REGIONAL REVIEW FINDING

Name of Proposal: Regent Riverwood

Review Type: Development of Regional Impact

Preliminary Report:	June 2, 2005	DEVELOPMENT OF REGIONAL IMPACT REVIEW REPORT	Project:	Regent Riverwood #743
Final Report Due:	July 01, 2005		Comments Due By:	June 16, 2005

V/C Ratios

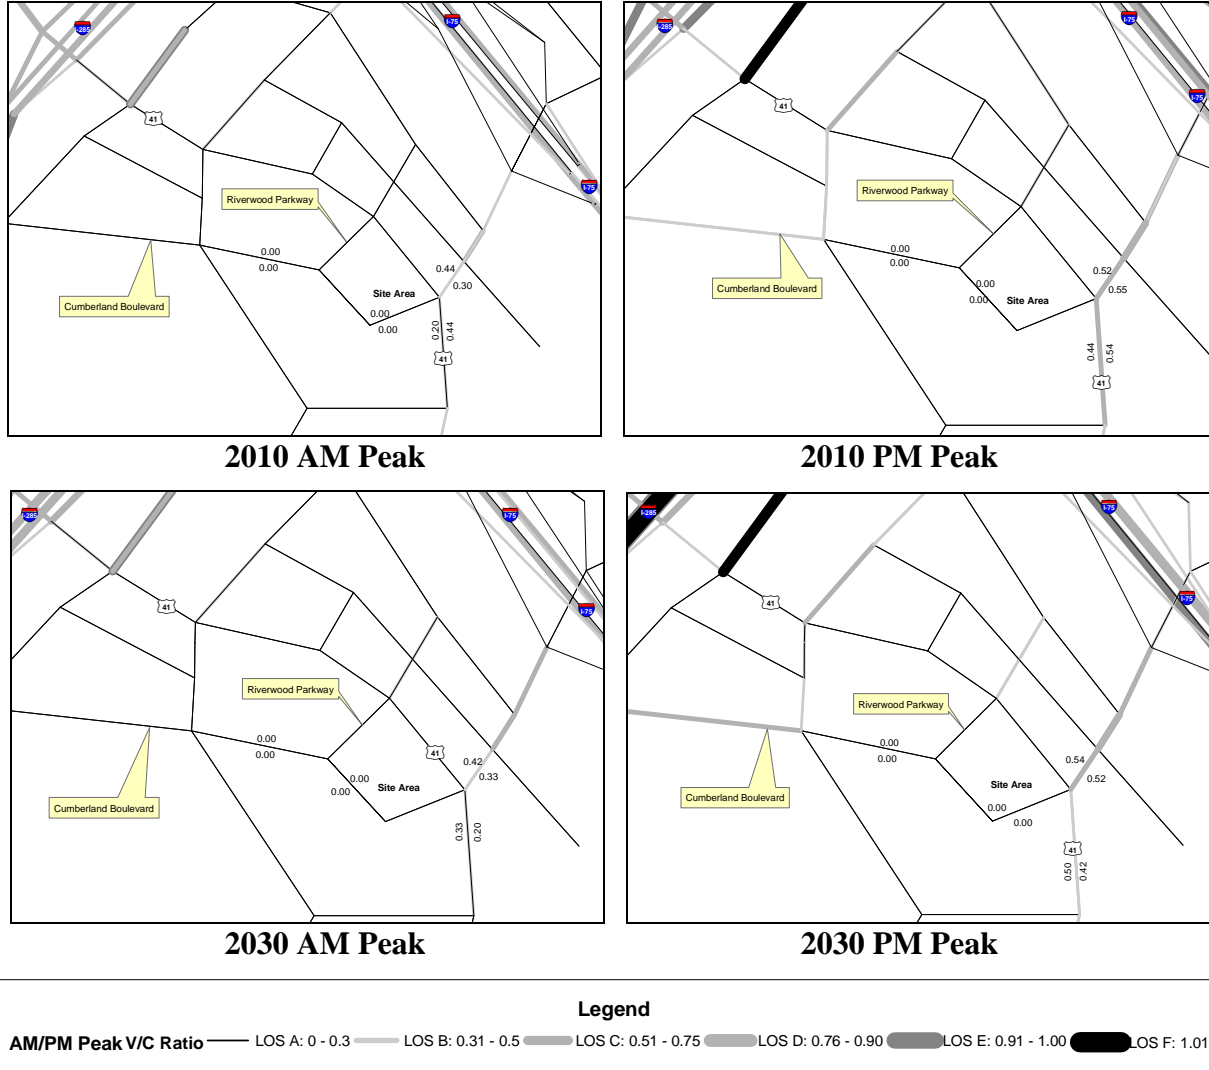
congestion increases. The V/C ratios for traffic in various network years are presented in the following table. Any facilities that have a V/C ratio of 1.0 or above are considered congested.

For the V/C ratio graphic, the data is based on 2005, 2010 and 2030 A.M./P.M. peak volume data generated from ARC's travel demand model for Mobility 2030, the 2030 RTP and the FY 2005-2010 TIP, adopted in December 2004. The travel demand model incorporates lane addition improvements and updates to the network as appropriate. As the life of the RTP progresses, volume and/or V/C ratio data may appear inconsistent due to (1) effect of implementation of nearby new or expanded facilities or (2) impact of socio-economic data on facility types.
